**Environmental
Planning
Commission**

**Agenda Number: 02
Project Number: 1009414
Case #: 12EPC -40061
December 6, 2012**

Staff Report

Agent	Mikaela Renz-Whitmore
Applicant	City of Albuquerque
Request(s)	Recommend Adoption of the Volcano Heights Sector Development Plan (SDP)
Legal Description	See attached map
Location	Paseo del Norte on the north and south, Universe Blvd. on the west, Petroglyph National Monument on the east
Size	Approximately 569.11 acres
Existing Zoning	RD, SU-1 PRD FAR. 5, SU-1 C-1 USES
Proposed Zoning	SU-2 VHTC (Town Center), SU-2 VHRC (Regional Center), SU-2 VHVC (Village Center), SU-2 VHMIX (Mixed Use), SU-2 VHNT (Neighborhood Transition), and/or SU-2 VHET (Escarpment Transition)
	General Design Regulations are associated to varying degrees with all properties within the Volcano Heights SDP boundary.

Example of a single loaded street in Taylor Ranch adjacent to the Monument

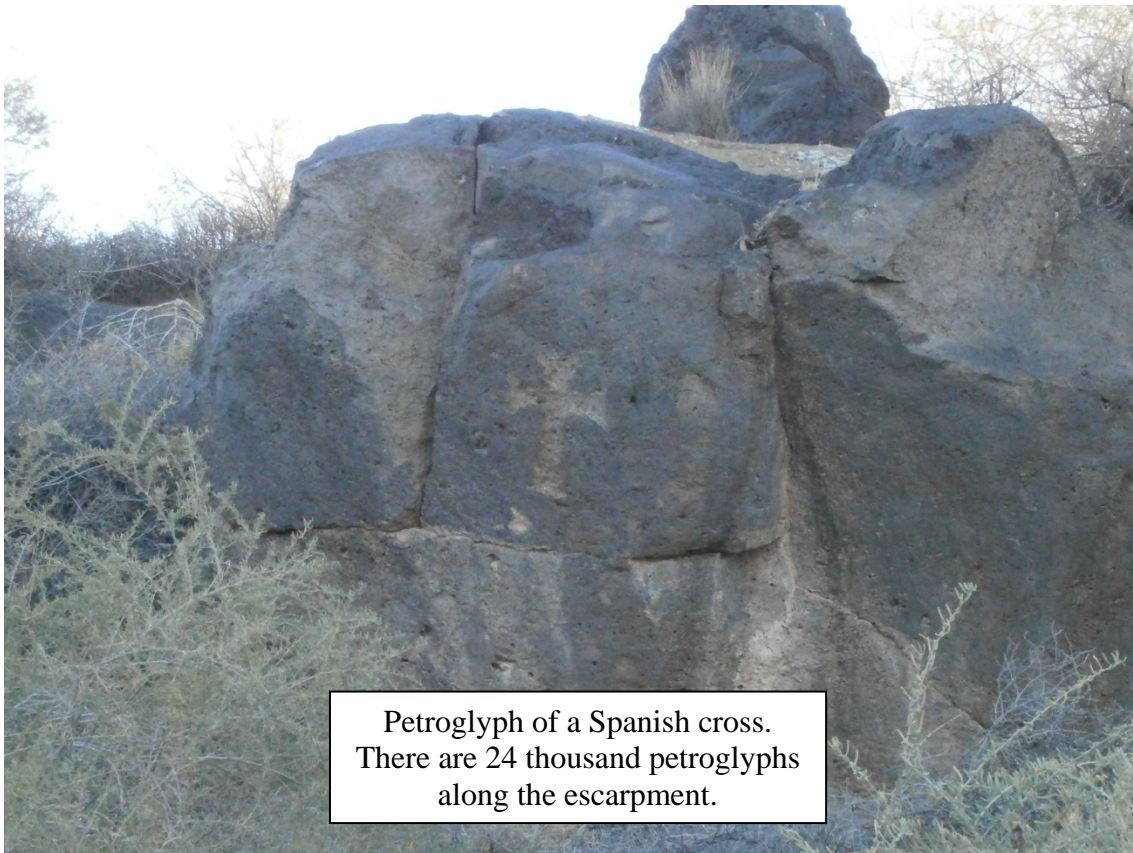
C) Attached below are photos exhibiting examples of the points made above:

Exhibit A.41 – Volcano Mesa Area Electrical Facilities Map

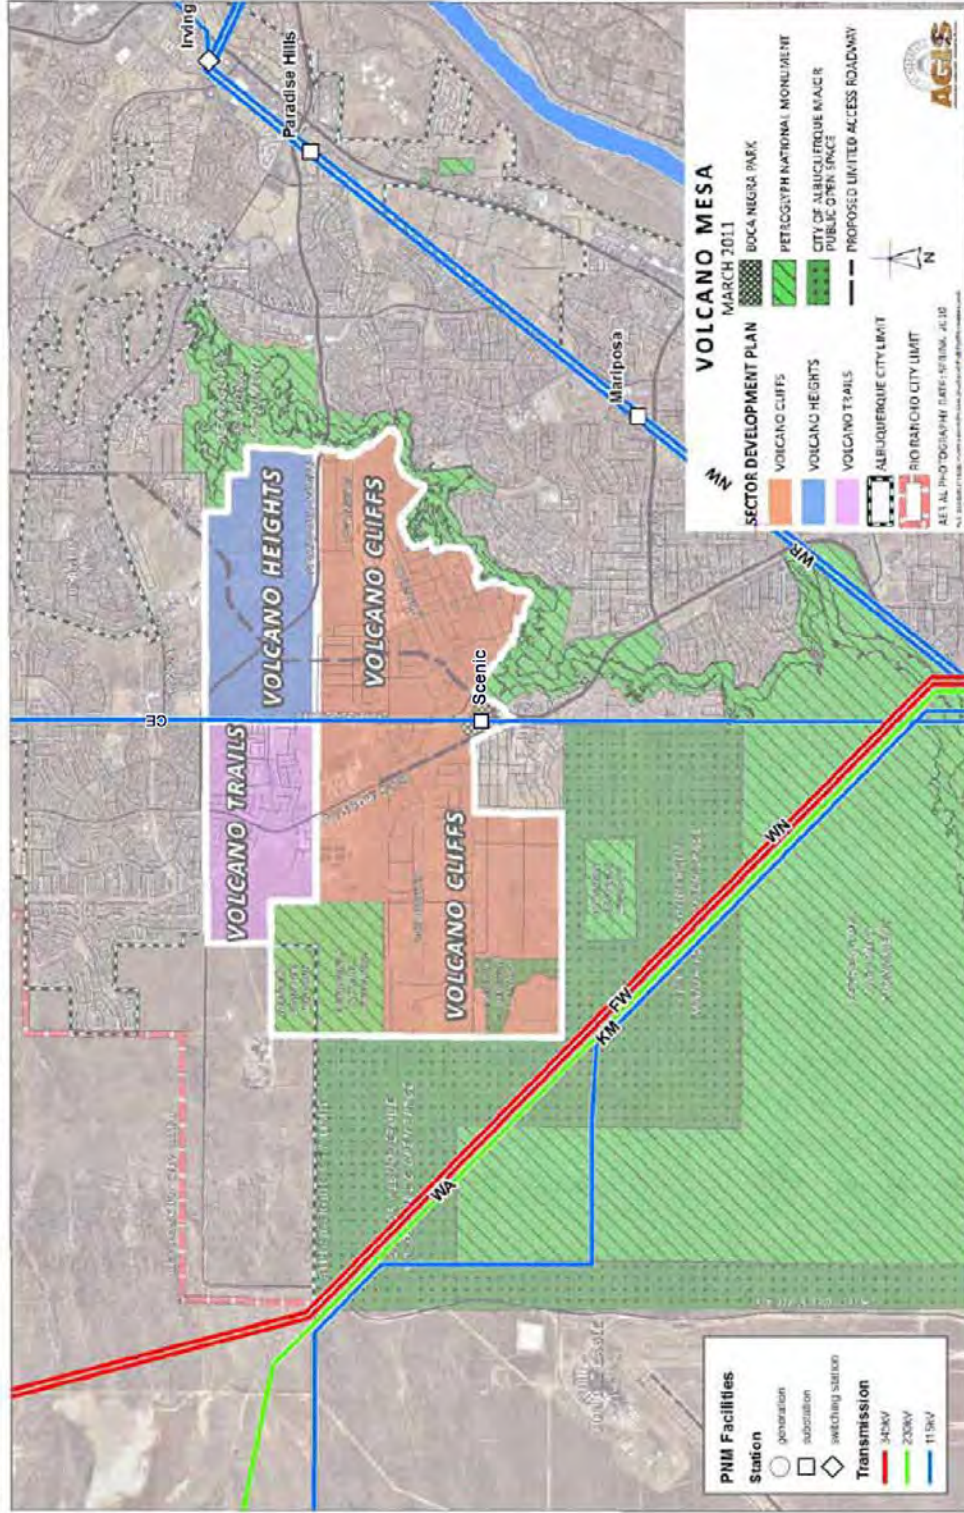
29. New facilities have been approved since the draft Plan’s Exhibit A.41 on page A-38 was created. Please replace Exhibit A.41 in the Plan with the enclosed revised Exhibit A.41 which indicates the location of the approved Scenic Substation under development.

Comment #	Section #	Page #	Comment / Question / Request for Change	No Change (+ explanation)	Change	Condition Language
AC	83	Exhibit A.31	A-38 New facilities have been approved since the draft Plan's Exhibit A.41 on page A-38 was created. Please replace Exhibit A.41 in the Plan with the enclosed revised Exhibit A.41 which indicates the location of the approved Scenic Substation under development.		Staff will replace the exhibit.	On page A-38, update Exhibit A.41.
